SERVICE BULLETIN No. BB/45

- 1. WITH REFERENCE TO:** Kubicek BB balloons with transparent windows of early design without a tape around the window foil edge (envelope serial numbers: 662, 663, 674, 709, 711, 714)

Distinction of envelope window designs

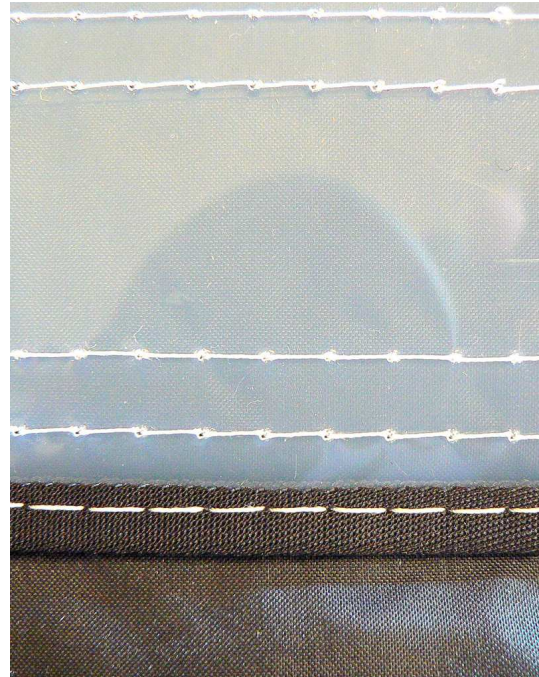
Window without edge tape - AFFECTED

Window with edge tape - NOT AFFECTED
